PALESE-VENTURI RESIDENCE

3023 Q STREET NW, WASHINGTON, DC 20007

REVISION TO BUILDING PERMIT #B1813138:

Revision to Permit #B1813138

PROPOSED
1ST FLOOR PLAN

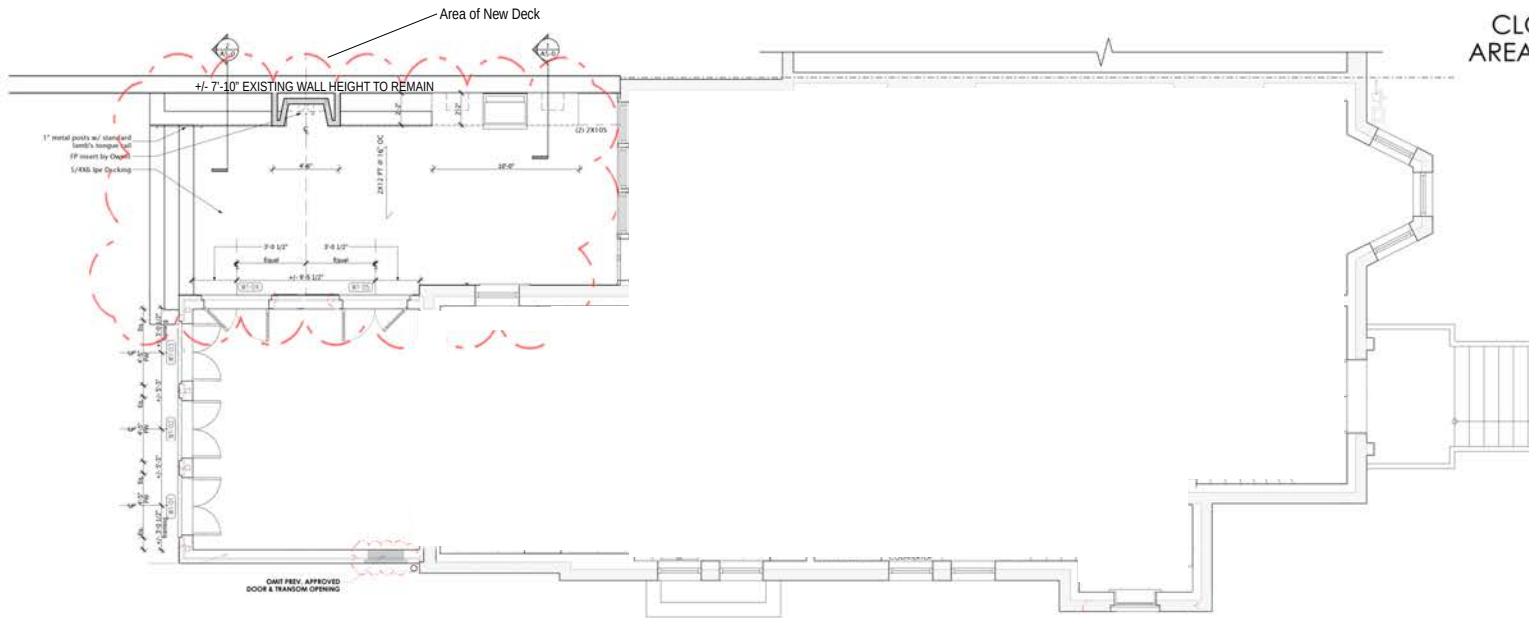
Remove previously approved entrance door on rear addition. Locate HVAC condensing units on rear addition roof. New Deck with grill and vent-free fireplace.

CLOUDS INDICATE
AREAS OF NEW WORK

PROPOSED
ROOF PLAN

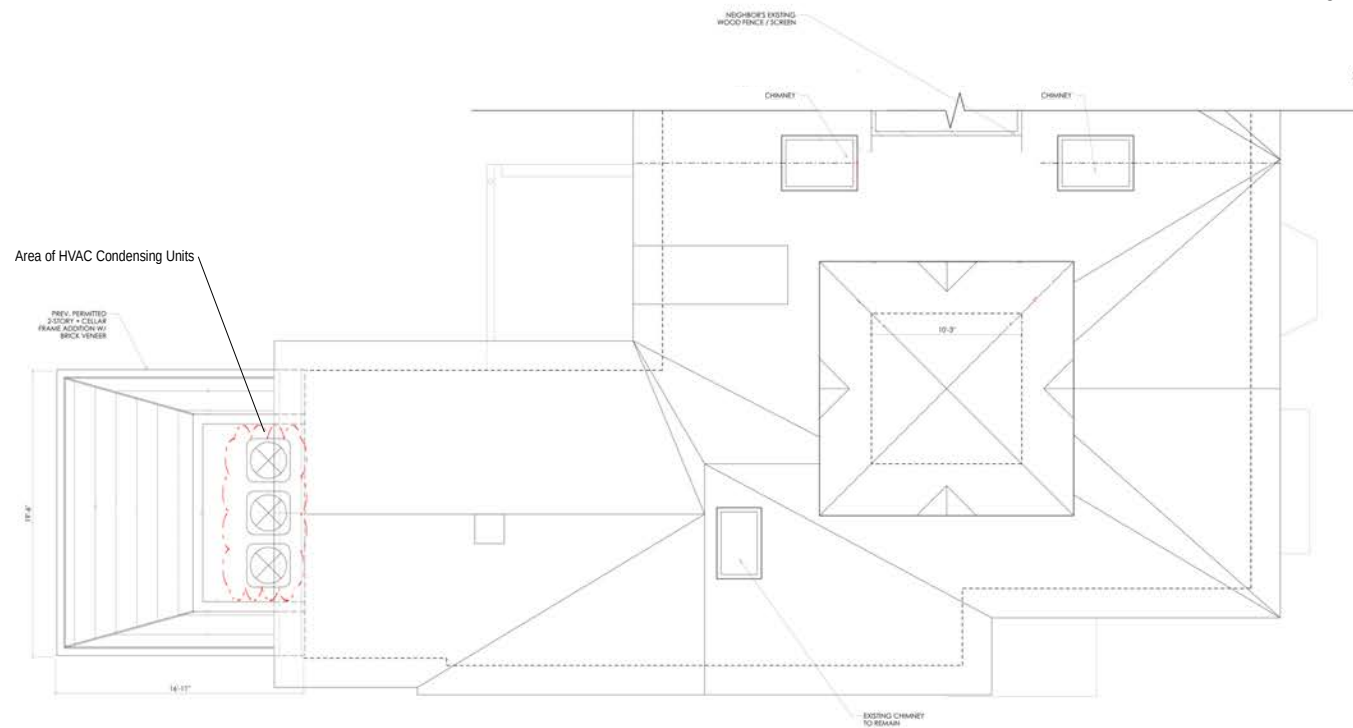
NEW CONSTRUCTION
(AMENDMENT)

PROPOSED
WEST EXTERIOR
ELEVATION

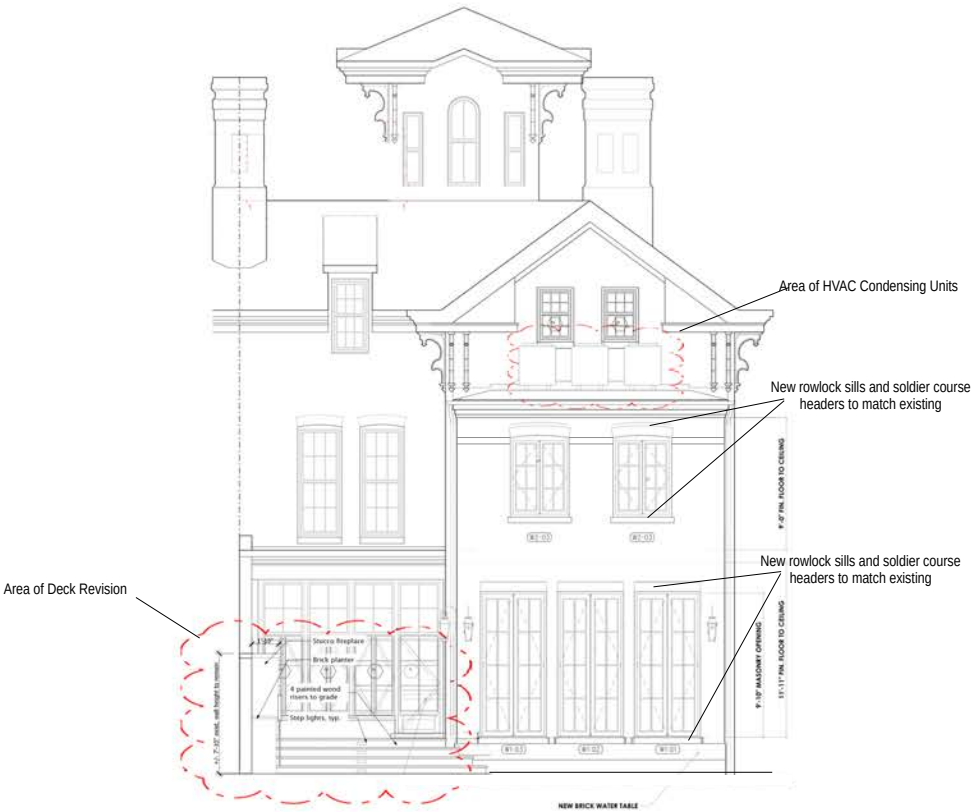
NEW BRICK HEADERS AND
SILLS TO MATCH EXISTING

PROPOSED
NORTH EXTERIOR
ELEVATIONS

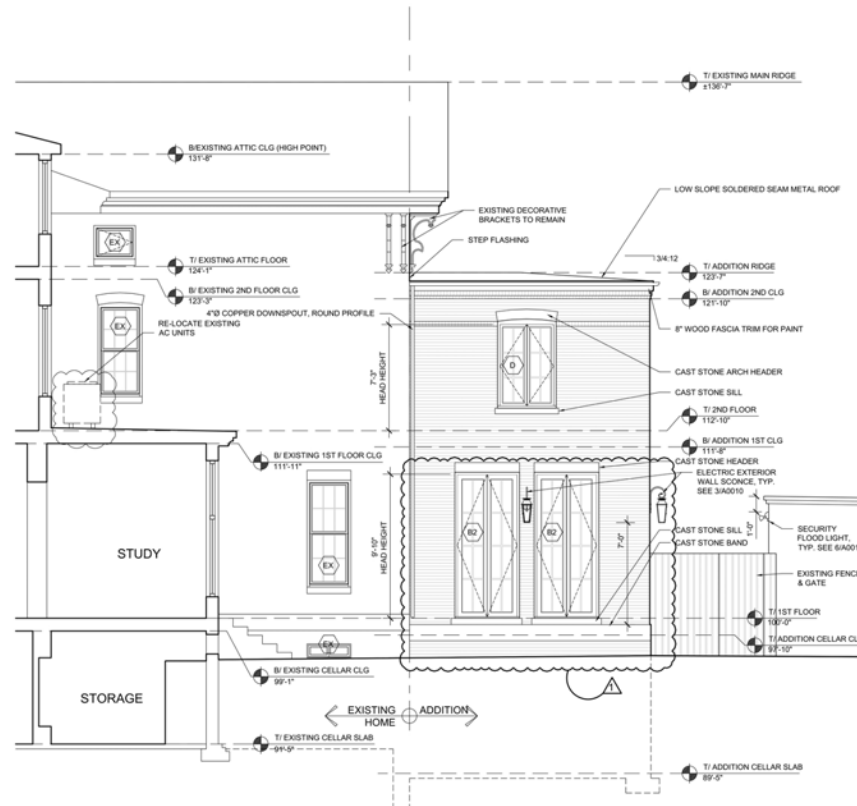
NEW BRICK HEADERS AND
SILLS TO MATCH EXISTING

PROPOSED
EAST EXTERIOR
ELEVATION

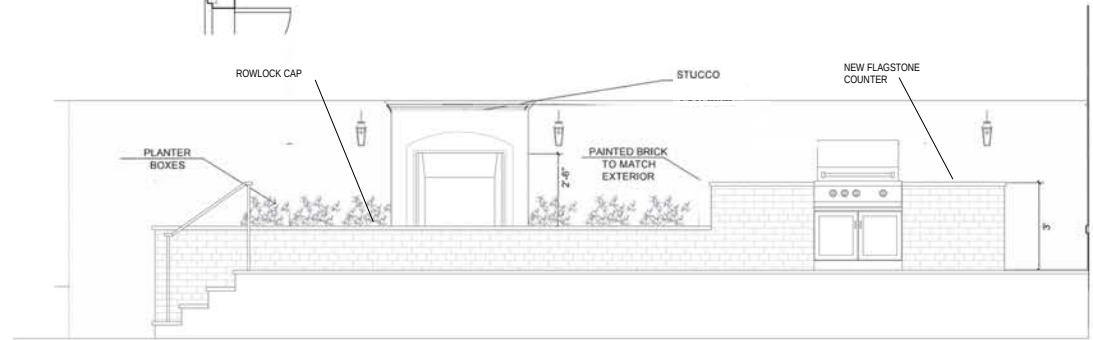
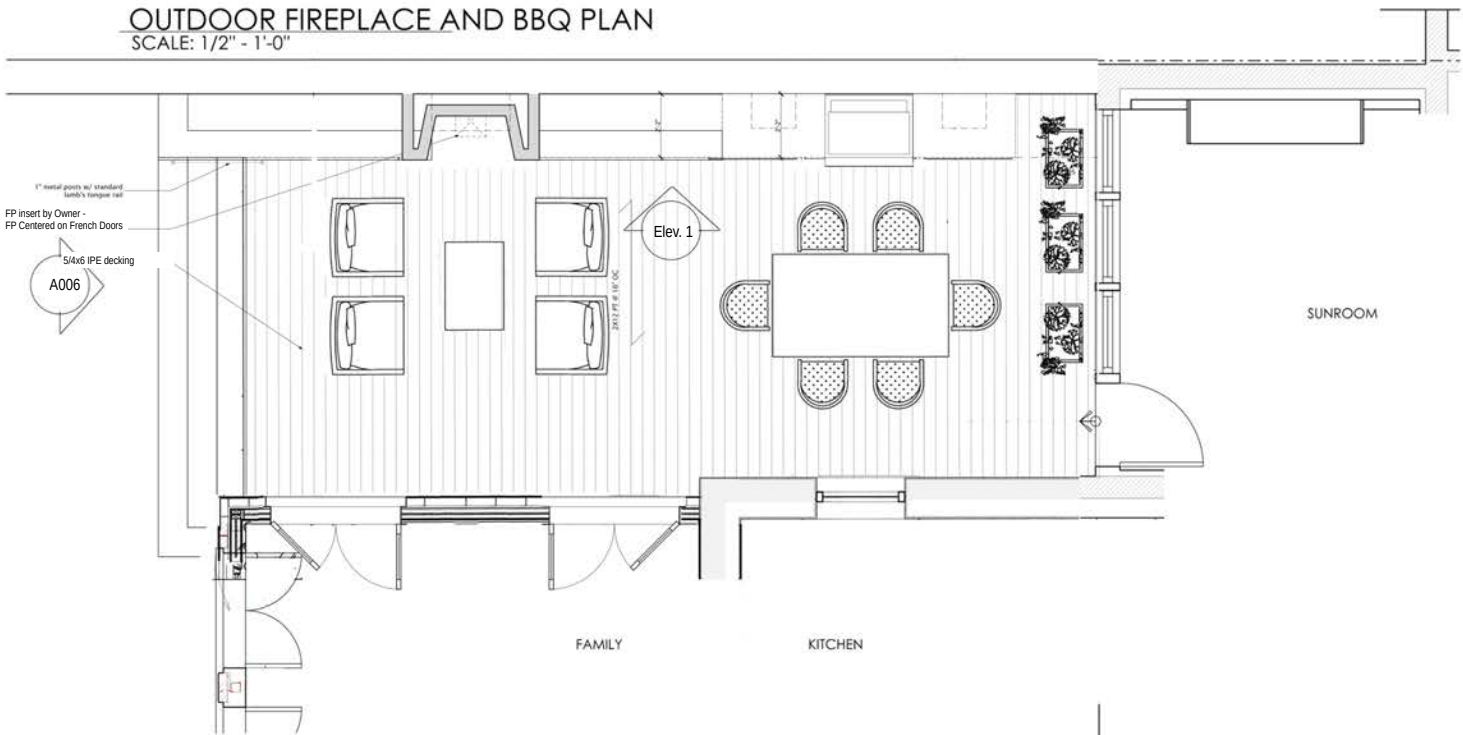
NEW BRICK HEADERS AND
SILLS TO MATCH EXISTING
